Subject/Title: Evaluation of Passive Sub-Slab Depressurization System
Former TRW Microwave Site, 825 Stewart Drive, Sunnyvale, CA

Re: Evaluation of Passive Sub-Slab Depressurization System, Former TRW Microwave Site, 825 Stewart Drive, Sunnyvale, California (CERCLIS ID#CAD00915988)

Former TRW Microwave Facility
Vapor Collection System - Roof Venting Compliance
825 Stewart Dr, Sunnyvale, CA
Project No: 60680270 Date: March 2022

Figure: 1

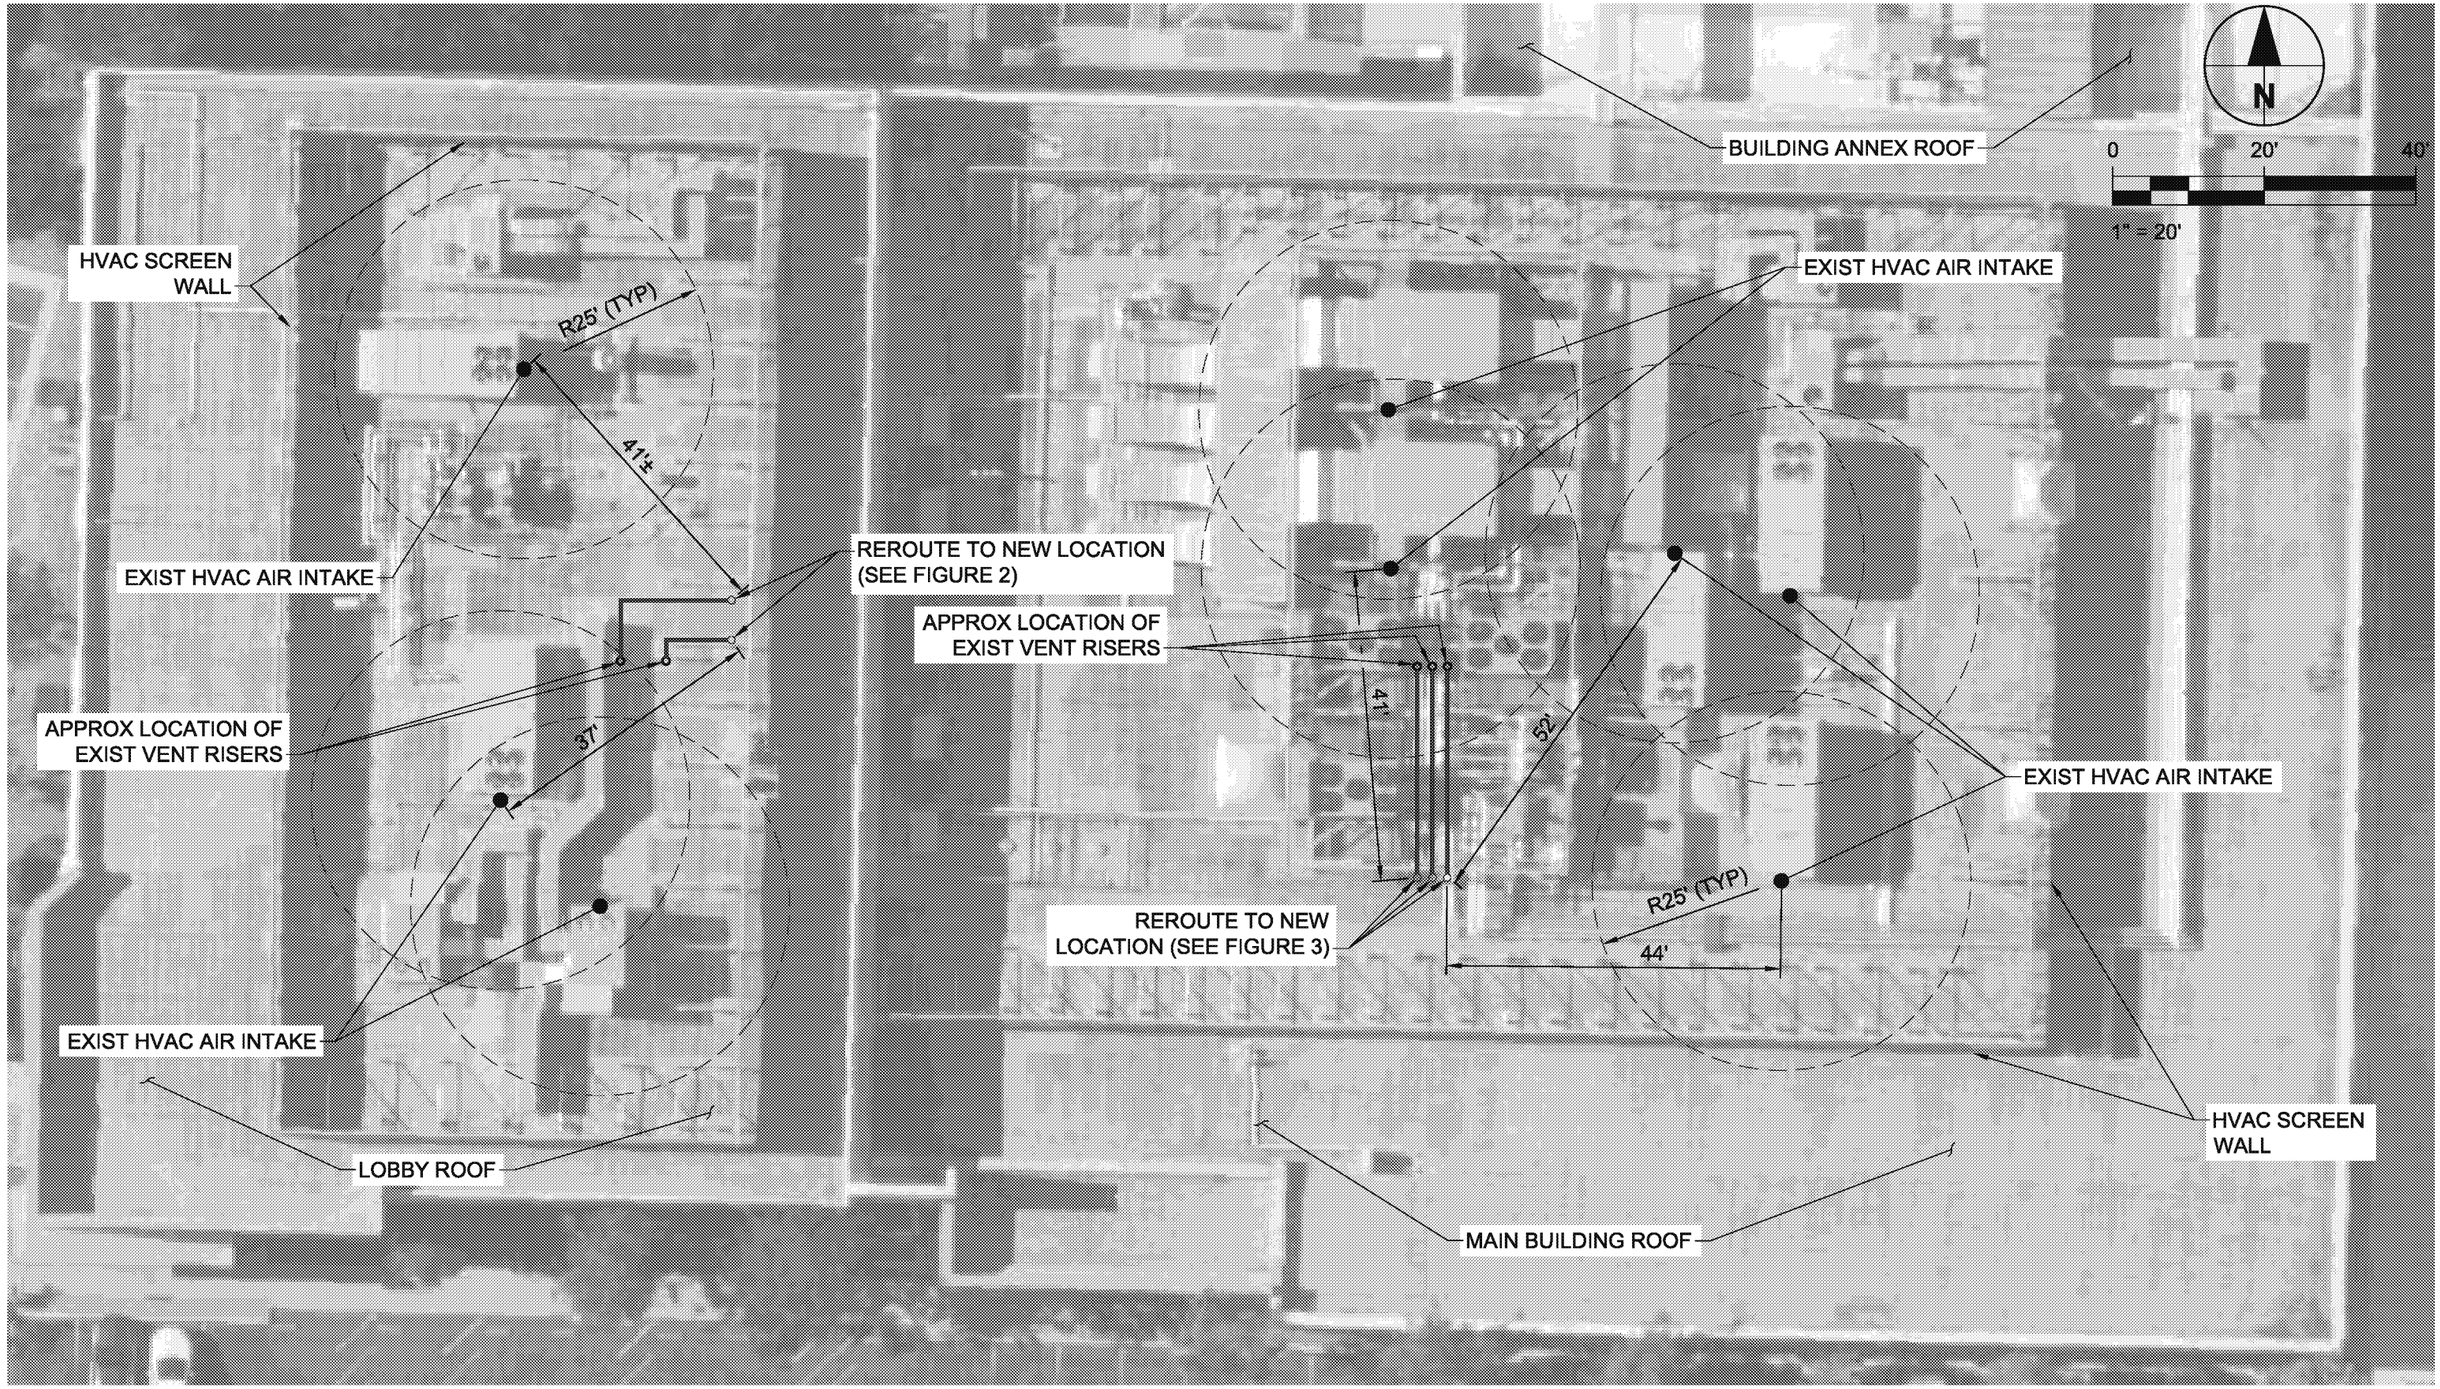
Figure 1 shows an aerial view of the three vents on the Main Building Roof and the two vents on the West Building roof and their proposed relocation outside the 25-foot spheres drawn around each intake.

The Main Building vent risers are proposed to be relocated approximately 27 feet to the south of the existing vents and approximately 42 feet from the nearest HVAC intake (**Figure 1**). The West Lobby Building vent risers are proposed to be relocated approximately 15 feet to the northeast, placing them approximately 37 feet away from the nearest HVAC intake (**Figure 2**). The height of the risers is designed to allow for airflow across the turbines while maintaining the overall building profile with all equipment located below the top of the windscreen at the edge of the building. The proposed piping schematic is shown on **Figure 3**. The scope of work will involve removing the existing turbines, trimming the vent to height, placing a 90-degree elbow, and routing the pipe horizontally to the new vent riser location as shown on **Figure 3**. The piping will be supported on the roof using Dura-blocks consistent with the existing supports for piping and conduit. The risers will be secured to existing structures as shown on **Figure 2** and **Figure 3**.
